**PLANNING DEPARTMENT ADMINISTRATIVE PUBLIC HEARING
SUMMIT COUNTY, UTAH
January 15, 2026**

Planning Department Staff Report

Subject: 1251 Kearns Boulevard
Application: PL-25-06747 (original CUP PL-22-05240)
Author: Elissa Martin, Planning Project Manager
Date: January 15, 2026
Type of Item: Extension of Conditional Use Permit

Subject: 841 Lowell Avenue
Application: PL-25-06632
Author: Meredith Covey, Planner II
Date: January 15, 2026
Type of Item: Historic District Design Review

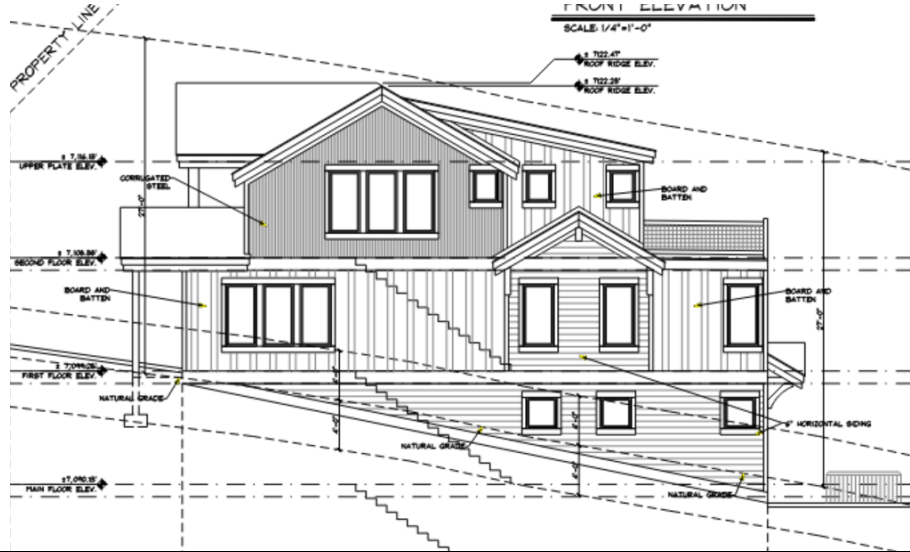
<p>Front and Rear Setbacks are established based on Lot Depth pursuant to LMC § 15-2.2-3. For a Lot that is 75 feet deep the Front and Rear Setbacks must be 10 feet each and a total of 20 feet.</p>	<p>Complies: 11-foot Front Setback 13-foot Rear Setback</p> <p>The proposed plans (Exhibit B) show a patio that encroaches into the Rear Setback. Pursuant to LMC § 15-2.2-3(H)(10) patios not more than 30” above Final Grade are permitted within one foot from the Rear Lot Line. The proposed patio is located one foot from the Rear Lot Line and is compliant.</p> <p>Pursuant to LMC § 15-4-2 Fences are permitted in the Rear Setback if they are less than 6 feet in height. The proposed Fence is 6 feet and is compliant.</p> <p>Pursuant to LMC § 15-2.2-3(H)(8) hot tubs are permitted no closer than 3 feet from the Lot Line. The proposed hot tub is 3 feet from the Rear Lot Line; Condition of Approval 20 requires that the hot tub be screened.</p> <p>Pursuant to LMC § 15-2.2-3(H)(10) pathways or steps not more than 30 inches above Final Grade are permitted one foot from the Rear Lot Line. The proposed pathway is compliant.</p>

<p>Side Setbacks are established based on Lot width pursuant to LMC § 15-2.2-3. For a Lot 25 feet wide the Side Setbacks must be 3 feet each with a total of 6 feet.</p>	<p>Complies:</p> <p>The Structure is set back 3 feet from each Side Lot Line.</p> <p>Pursuant to LMC § 15-2.2-3(J)(4) 1 foot roof overhangs are permitted on Lots with a Side Setback of less than five feet. The proposed roof overhangs are one foot and are compliant.</p>

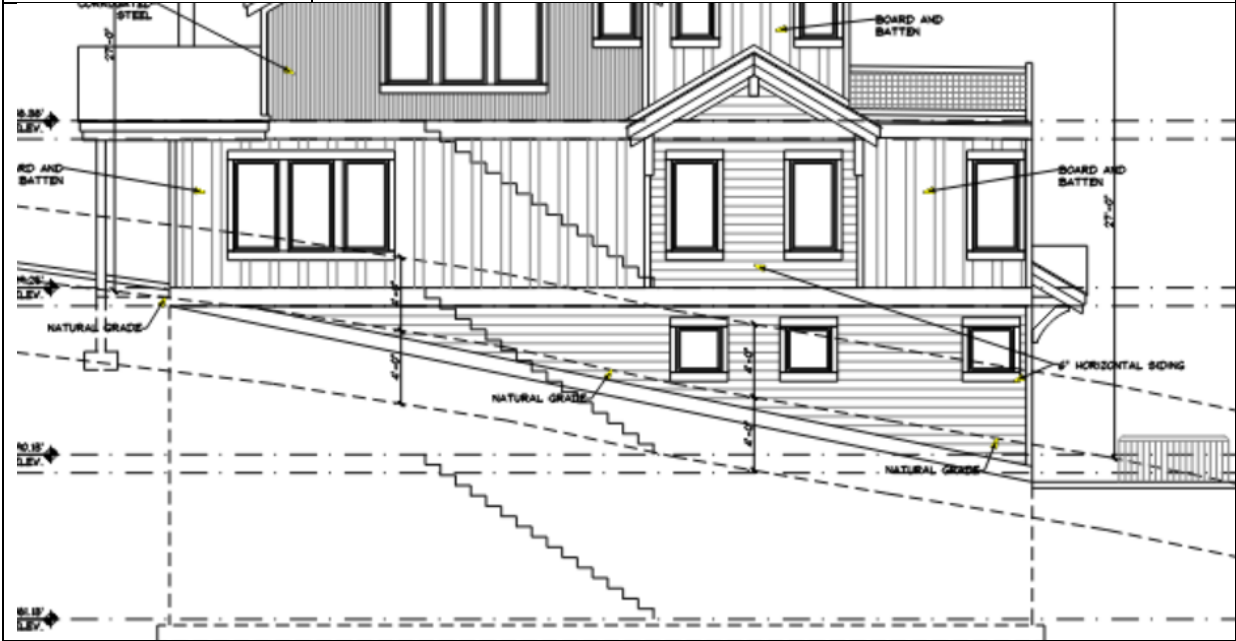
<p>Final Grade within 4 feet of Existing Grade</p>	<p>Complies: The Applicant was issued a Determination of Interpolated Grade by the Planning Director on October 14, 2025 (Exhibit C). The proposed Final Grade is within four feet of existing grade as shown below:</p>
--	---

Figure 2: Location of the patio where the Temporary Structure will be installed. Image provided by Applicant (Attachment 1).

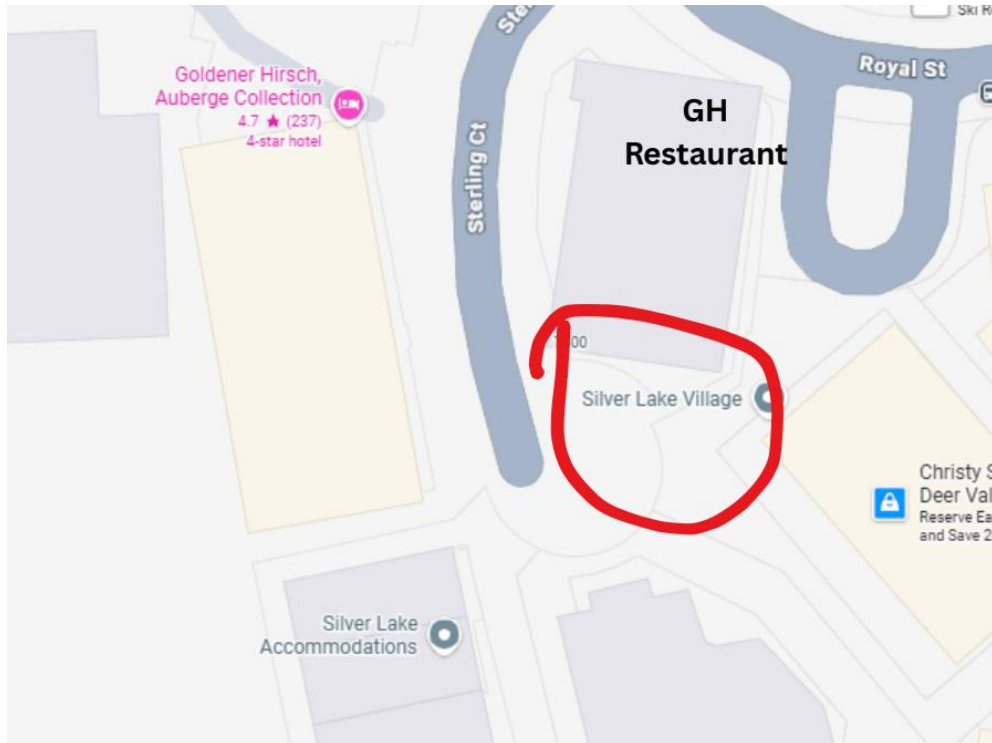
The Temporary Structure would be located on an outdoor patio at The Hirsch Restaurant.
